Addendum 03

DATE: February 2, 2026

PROJECT: Tipp City Seniors New Addition
528 North Hyatt Street
Tipp City, Ohio 45371

PROJECT #: 25059.00

SHEET NUMBER:
G1.0

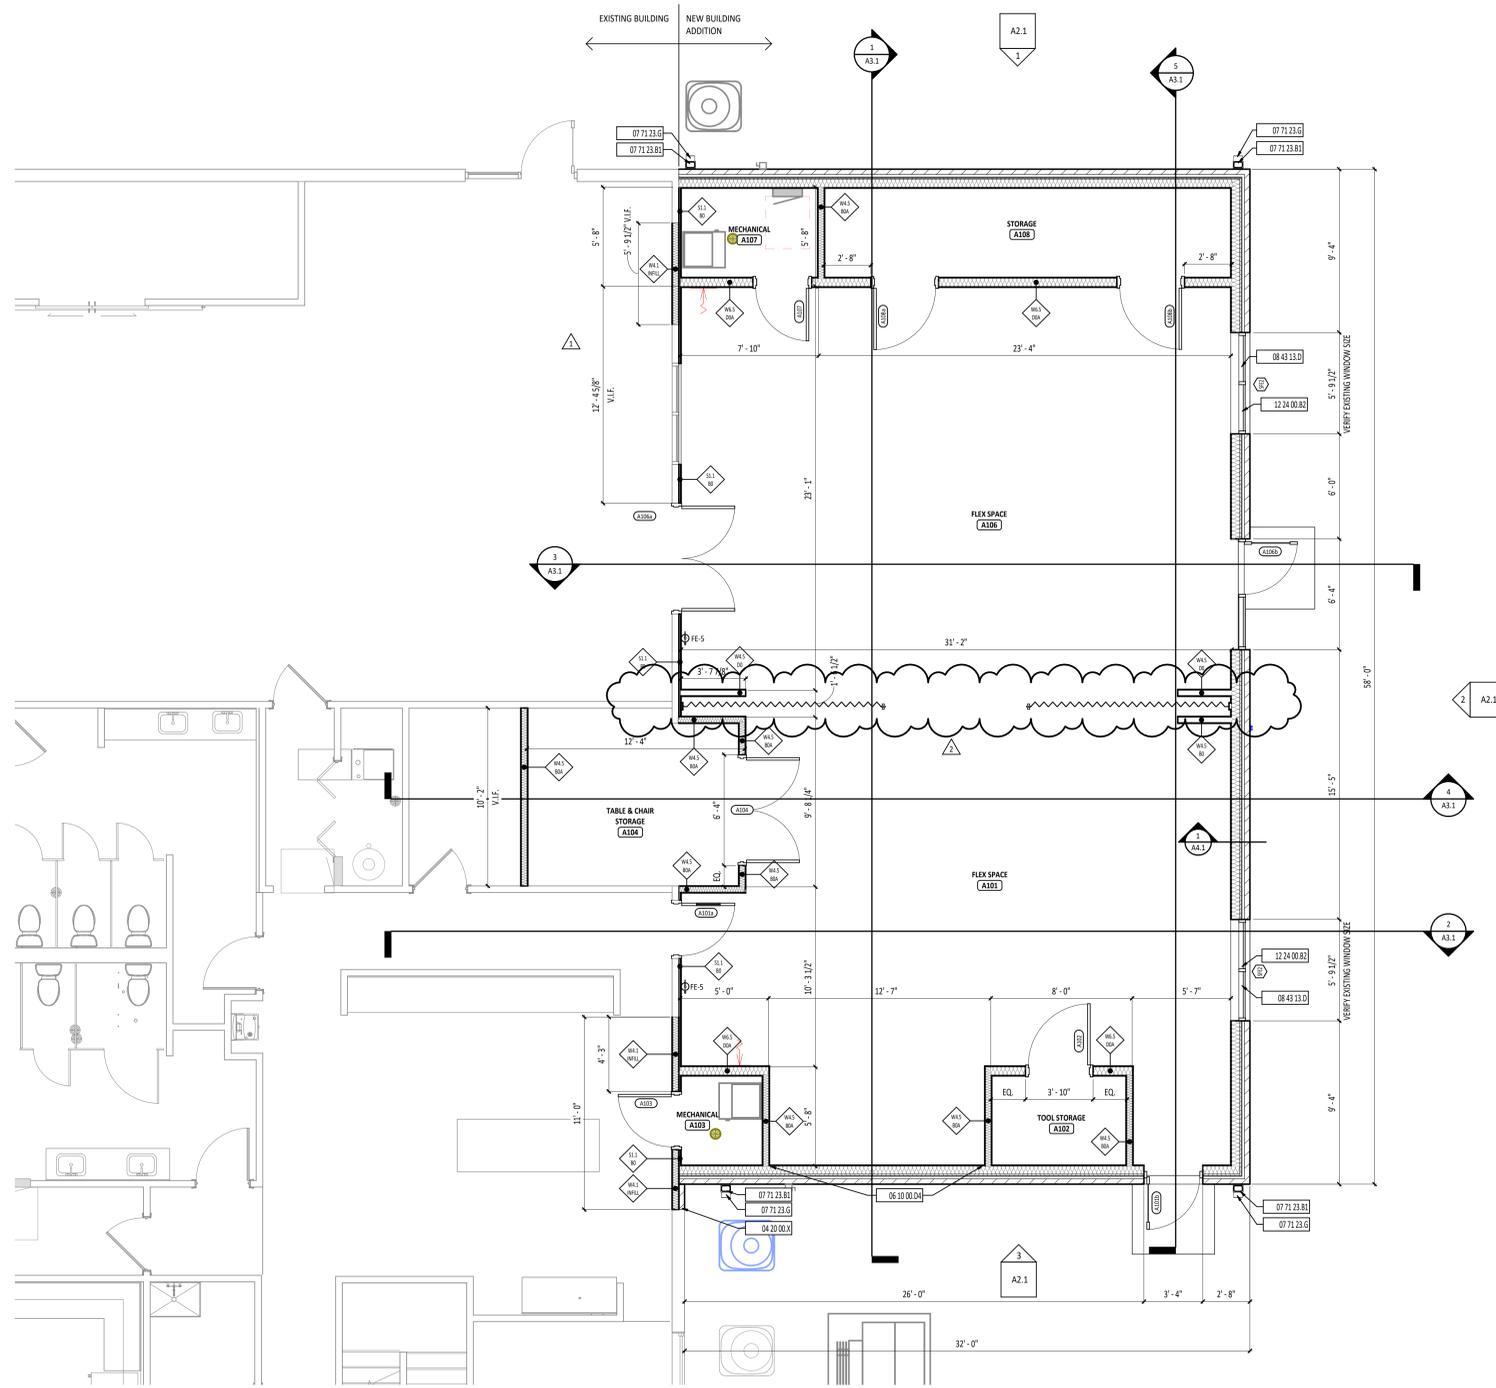
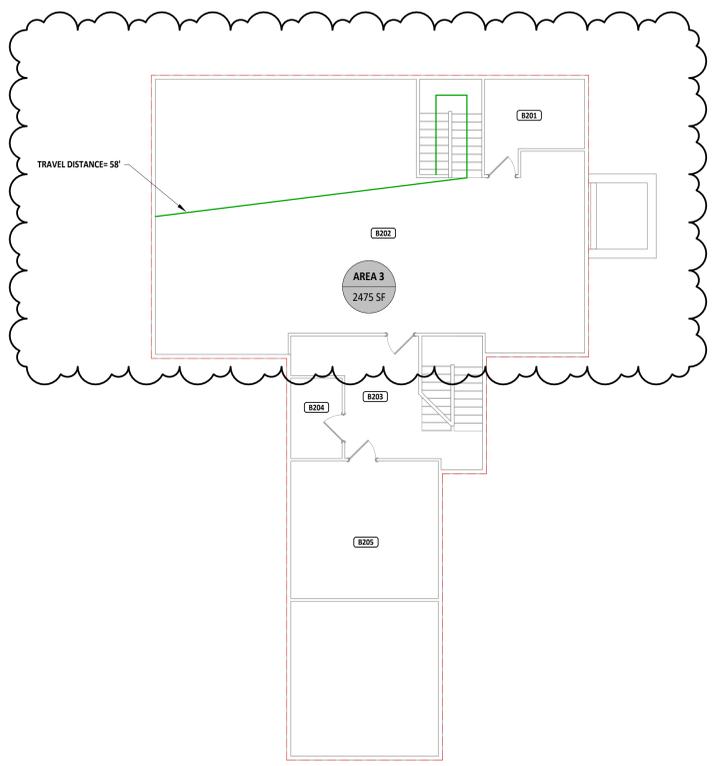
1. Drawing Sheet G1.0 First & Second Floor Code Plan:
 - a. Added second floor code plan
 - b. Added travel distances
 - c. Added exit separation distance

SHEET NUMBER:
A1.1

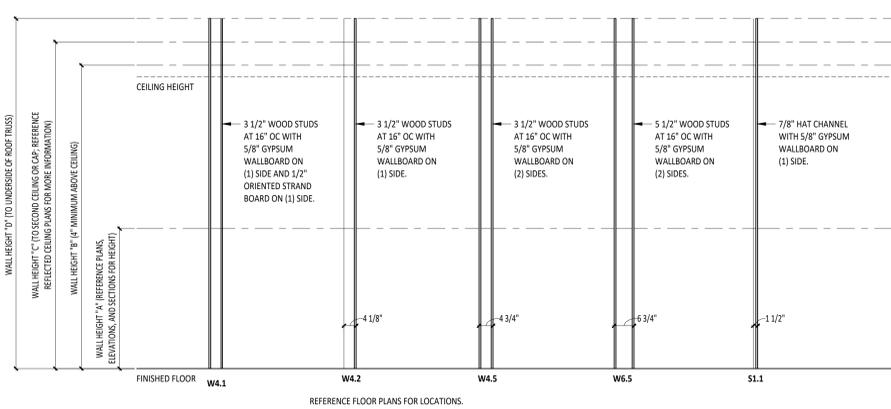
2. Drawing Sheet AD1.0 First Floor and Reflected Ceiling Demolition Plan:
 - a. Added an additional portion of the existing wall to be demoed.
3. Drawing Sheet A1.1 First Floor Plan – Unit A:

- a. Location of accordion door moved to reduce the size of A106 to reduce the occupant load.
4. Drawing Sheet A6.1 Door Schedule & Door Details
 - a. Added hardware set number five for exterior aluminum storefront doors.

SHEET NUMBER:
A6.1

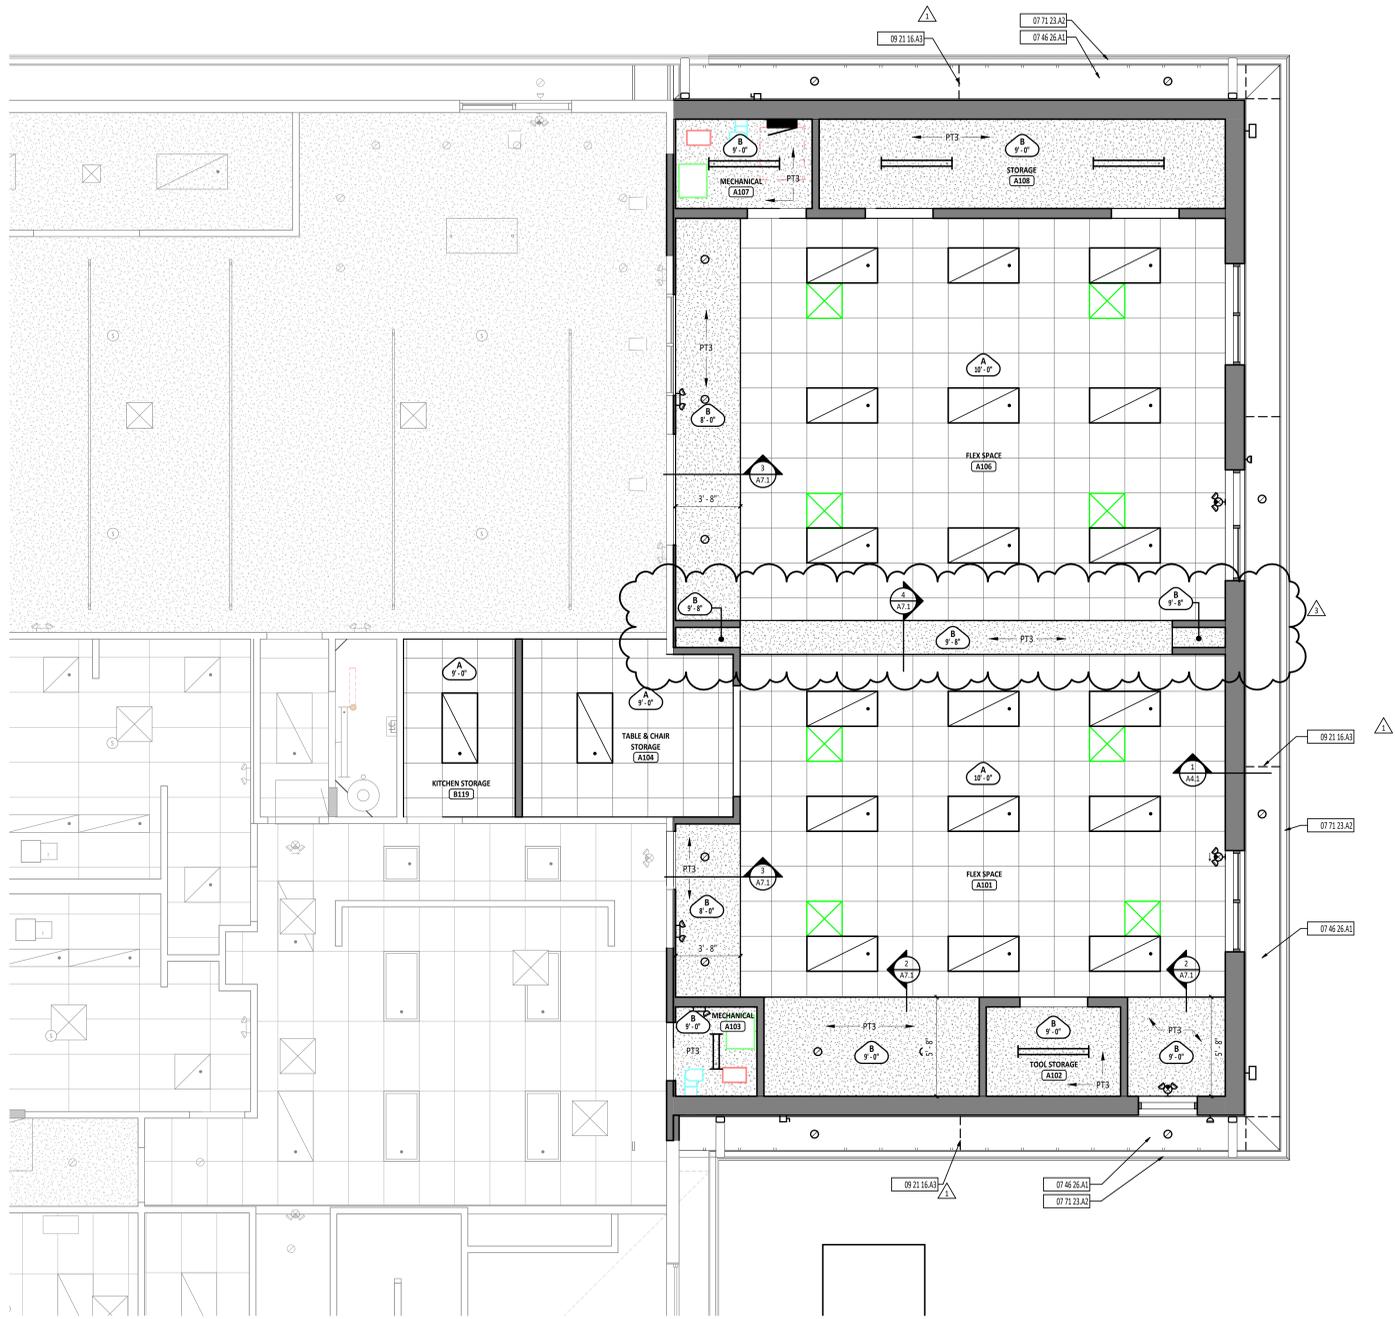
- b. Revised quantity of silencers for hardware sets three and four
5. Drawing Sheet A7.1 First Floor Reflected Ceiling Plan – Unit A
 - a. Location of accordion door moved to reduce the size of A106 to reduce the occupant load. Ceiling revised to reflect this change
